CLAREMONT BUSINESS PARK FILING NO. 3

STREET IMPROVEMENT PLANS

WATER QUALITY POND 2 SITE PLAN

SAND FILTER WATER QUALITY POND 2 (PRIVATE)
SPILLWAY SECTION
NOT TO SCALE

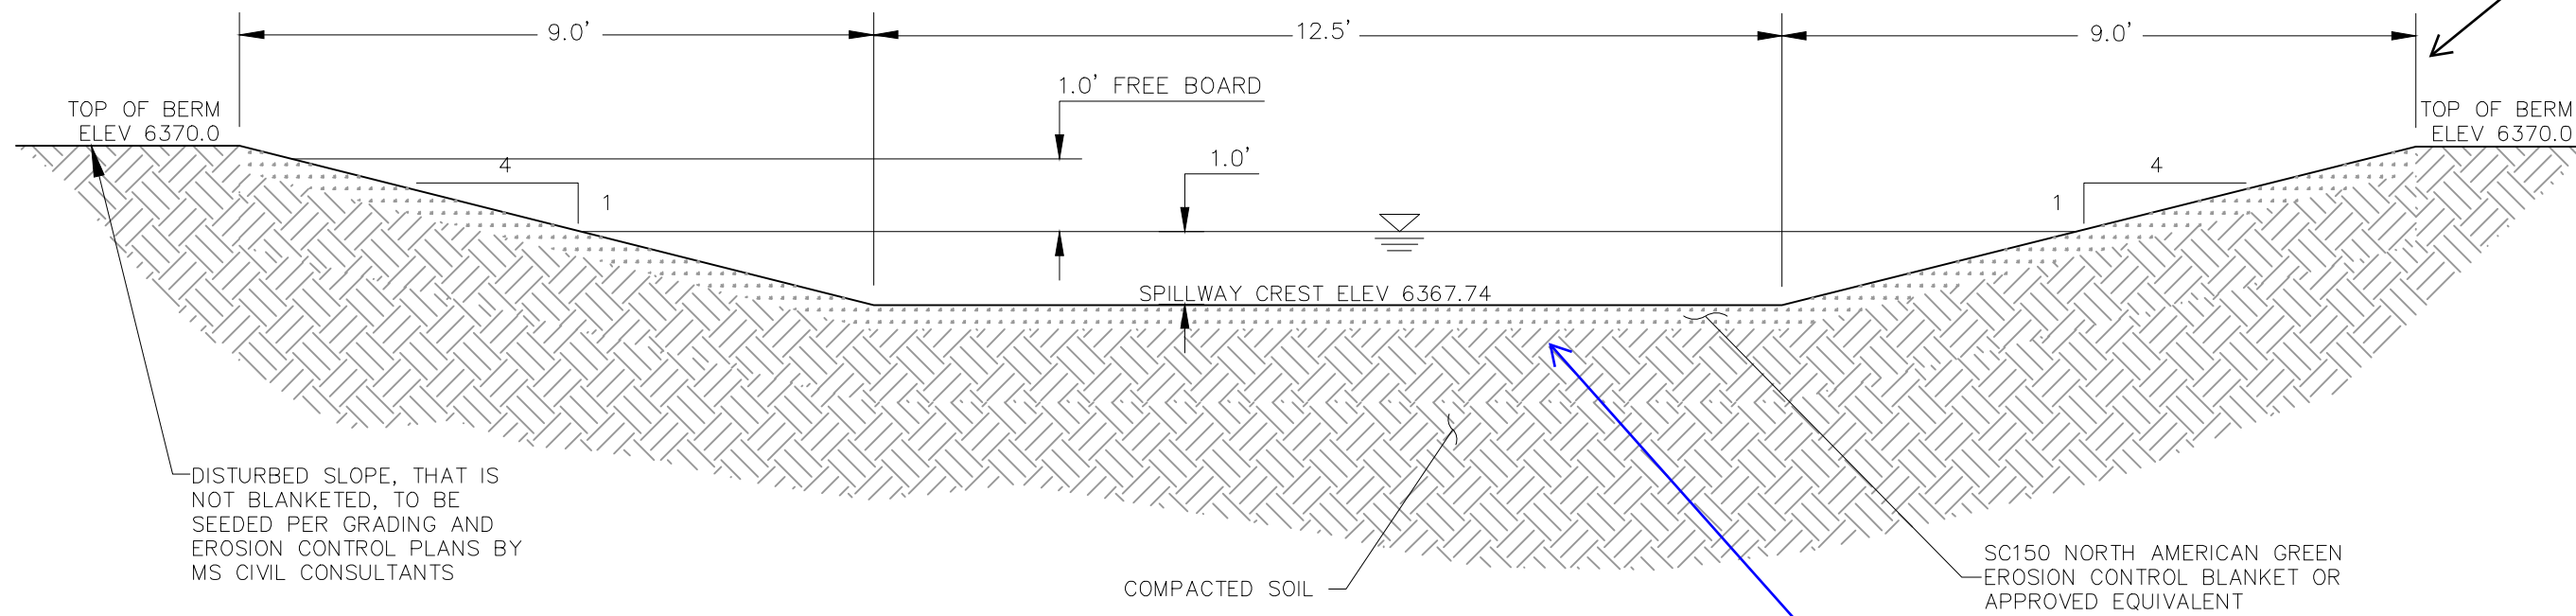
Drainage Report page
40 of 82 shows
spillway with Soil
Riprap and a Concrete
Overflow Wall. But
neither shown on this
detail.

REVISE SPILLWAY
TO INCLUDE ACCESS
ROAD AND SC150
